Application No. 10/774,899
Amendment "A" dated September 28, 2005
Reply to Office Action mailed June 28, 2005

AMENDMENTS TO THE DRAWINGS

Title: MOUNTING SYSTEM FOR AN X-RAY TUBE
Inventors: David Craig Smith, et al.
Docket No.: 14374.105

Fig. 1

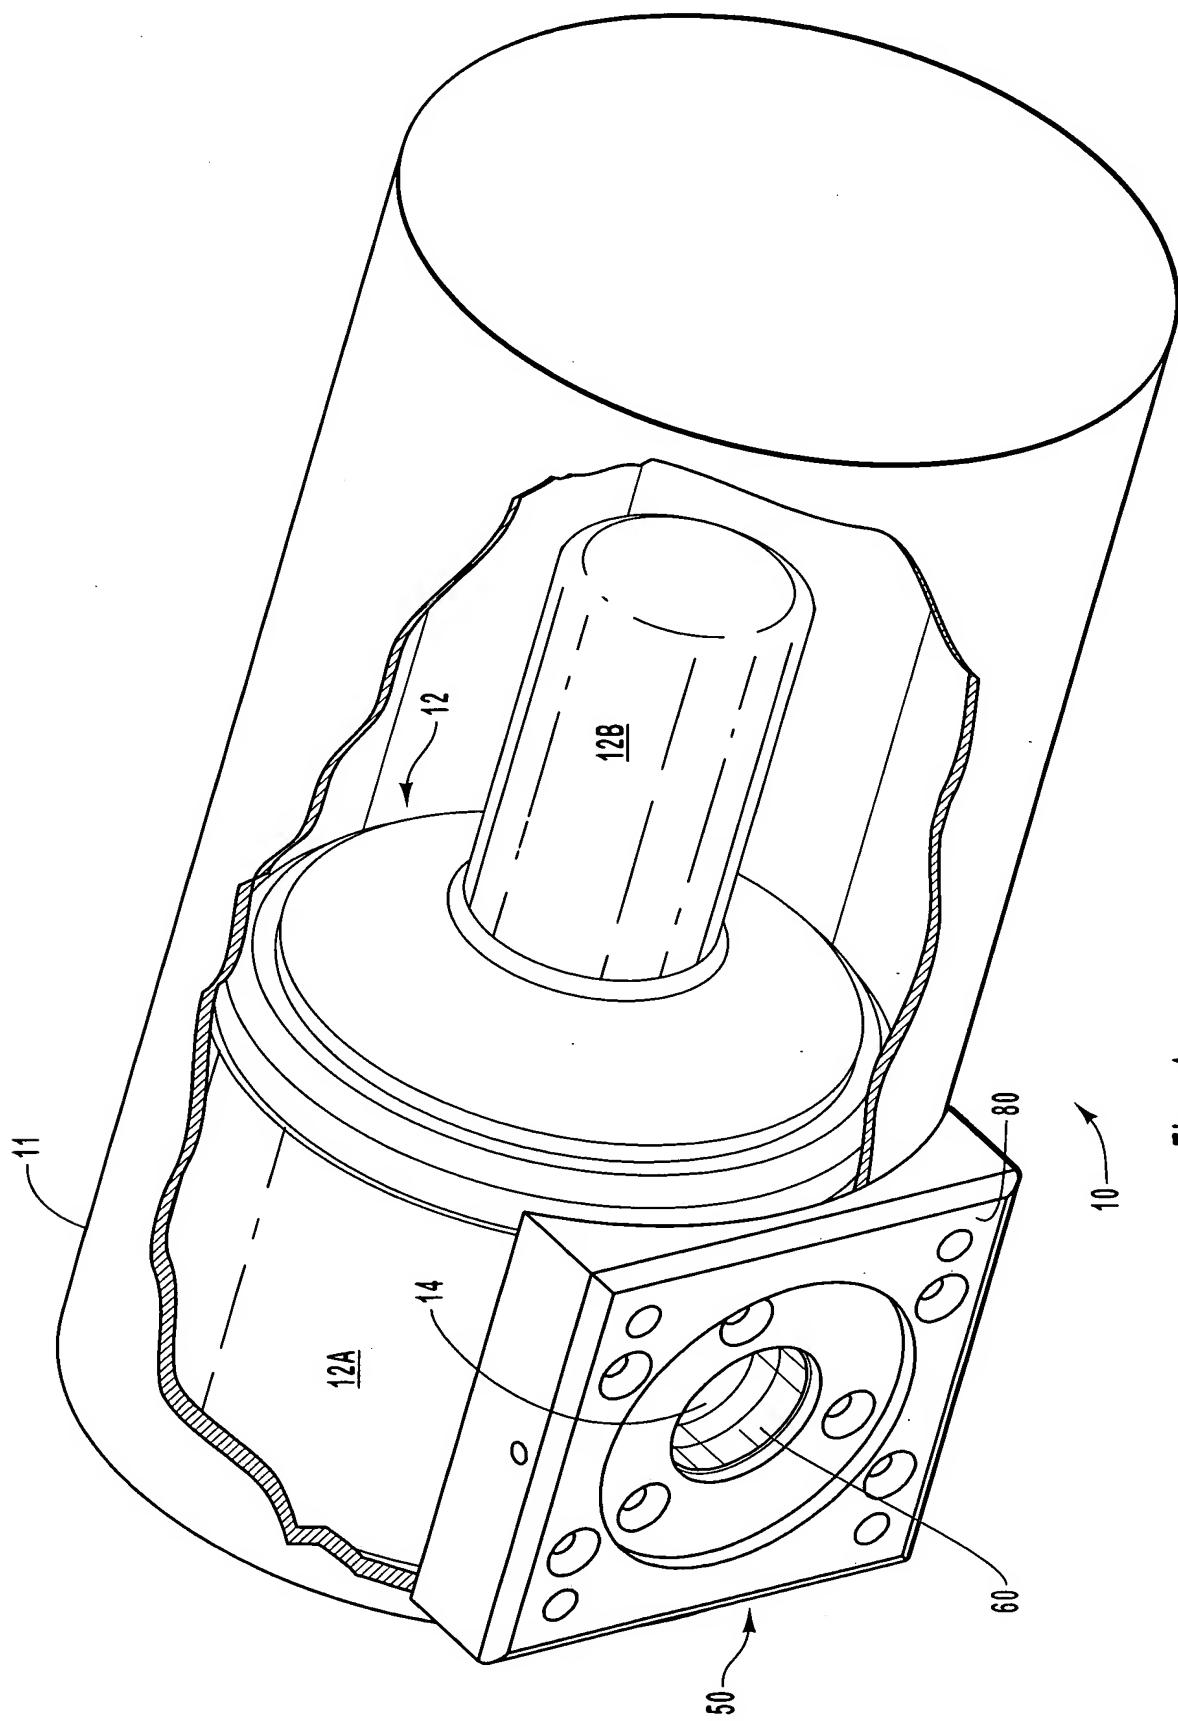
The Office Action objects to the drawings under 35 C.F.R. §1.83(a), alleging their failure to show every feature of the invention as specified in the claims. In particular, the Office Action alleges that the drawings fail to show a clamp portion mechanically attached to a bracket portion through an aperture defined in an outer housing. Applicants respectfully disagree with the assertion made in the Office Action by noting that at least Figures 1 and 8B depict the

mechanical attachment of the clamp portion and the bracket portion through an aperture defined in an outer housing. For instance, Figure 1 depicts the aforementioned attachment, though Applicants note that the aperture of the outer housing 11 through which attachment is achieved is omitted by virtue of the figure's cut-away view. Figure 8B explicitly shows a similar clamping portion/bracket portion attachment scheme similar to Figure 1, wherein such attachment is established through an aperture 112 in the outer housing 11. The aperture 112, though partially seen in Figure 8B, is clearly depicted in Figure 8A.

In the interest of clarifying the above attachment arrangement, Figures 1, 8A, and 8B have been amended to include explicit numeric references as originally included in the specification and other accompanying figures, to the clamp portion 60 and the aperture 112. Applicants submit that no new matter has been added as a result of these amendments because each of these components was not only depicted in the drawings as originally submitted, but also explicitly referred to by its reference number in the specification. Indeed, the case of aperture 112, only an oversight prevented inclusion of its numeric designation in Figures 8A and 8B. For the Examiner's convenience, replacement sheets including amended Figures 1, 8A, and 8B, together with original sheets of these figures showing the changes made in red ink, are included as an attachment following page 25 of this Response. Entry of these drawing amendments and removal of the objections to the drawings is therefore respectfully solicited.
